**SUBJECT: NEW VEHICLE DEMONSTRATION / DELIVERY HOLD -
 Safety Recall 19S11**

Certain 2015 - 2019 Model Year F-150 and 2017 – 2019 Model Year F-Super Duty
 Vehicles Equipped with Engine Block Heaters
 Disable Engine Block Heater Cord

CERTAIN 2015 - 2019 MODEL YEAR F-150 AND 2017 – 2019 MODEL YEAR F-SUPER DUTY VEHICLES EQUIPPED WITH ENGINE BLOCK HEATERS — DISABLE ENGINE BLOCK HEATER WIRE CORD

FIGURE 1

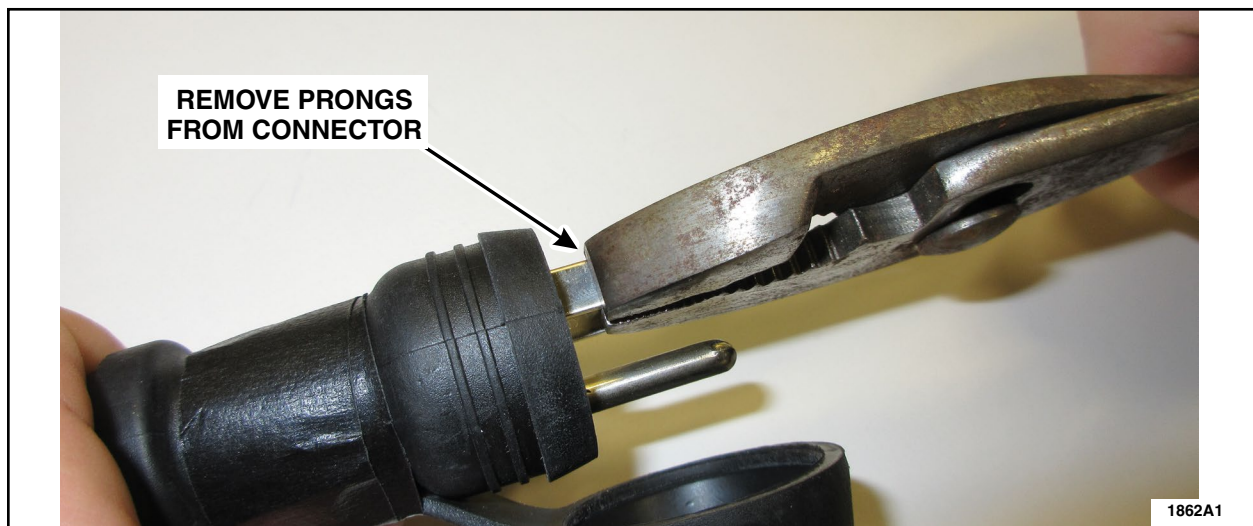
1. Remove the three prongs on the block heater cord using pliers, by bending the prongs back and forth to break the prongs off. See Figure 1.

FIGURE 2

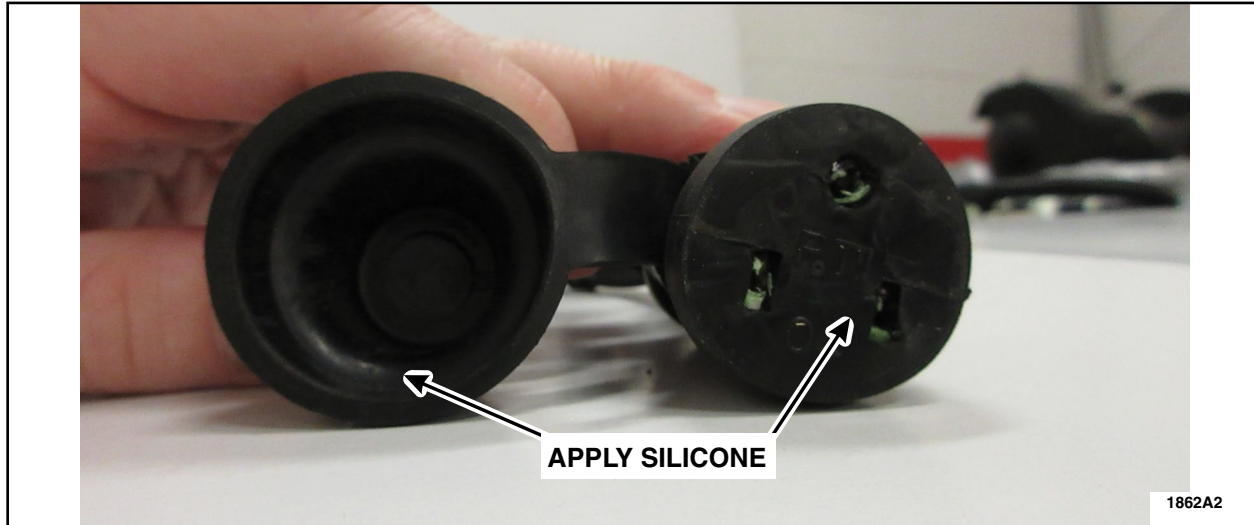
2. Apply Motorcraft silicone sealant TA-32 or equivalent to the cap and plug end. See Figure 2.

FIGURE 3

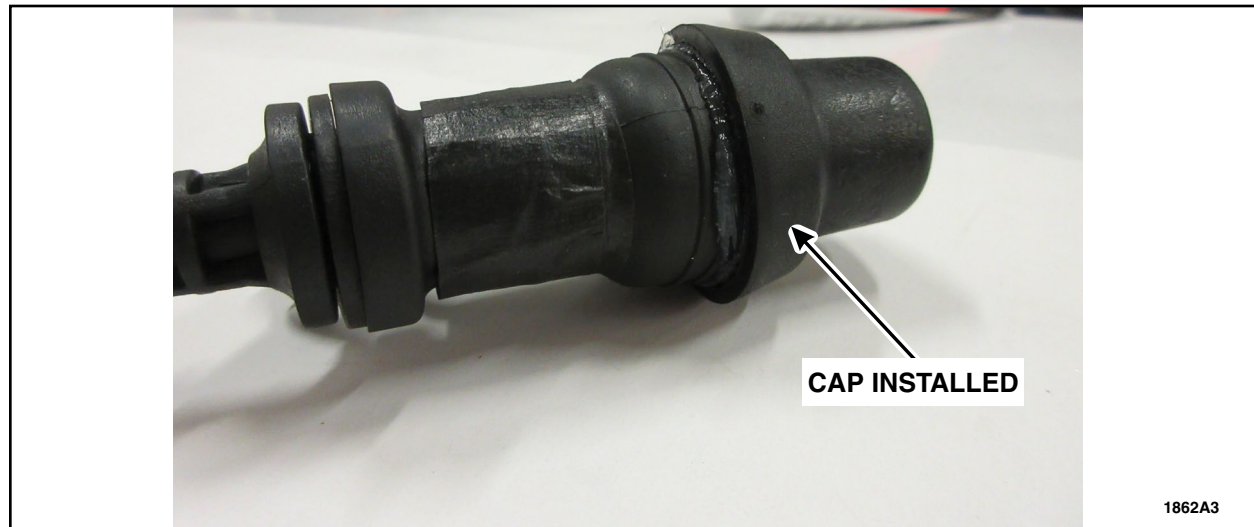
3. Install the cap back onto the block heater cord plug end. See Figure 3.
